D & B SUBDIVISION

The plat illustrates the proposed 3.8± acre, 2-lot subdivision, which is located on the East side of East I-65 Service Road South, 1220'± South of Cottage Hill Road, and is in Council District 5. The site is served by public water and sanitary sewer.

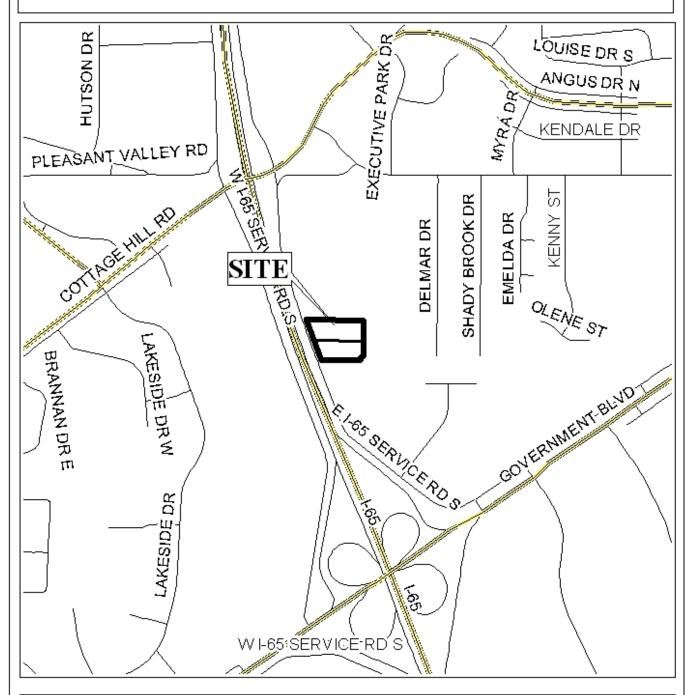
The site fronts East I-65 Service Road South, with a 300-foot right-of-way, and Grayson Drive, with an unopened right-of-way of varying width. Grayson Drive is in the process of being vacated in its entirety, so dedication of additional right-of-way is not necessary. As a means of access management, each lot should be limited to a single curb cut to East I-65 Service Road South, with size, location, and design to be coordinated with Traffic Engineering and Urban Development.

The required 25-foot building setbacks are not shown, but would be required on the final plat.

The plat meets the minimum requirements of the Subdivision Regulations and is recommended for Tentative Approval, subject to the following conditions: 1) depiction of the 25-foot setback lines on the final plat; and 2) the placement of a note on the final plat stating that each lot is limited to a single curb cut to East I-65 Service Road South, with size, location, and design to be coordinated with Traffic Engineering and Urban Development.
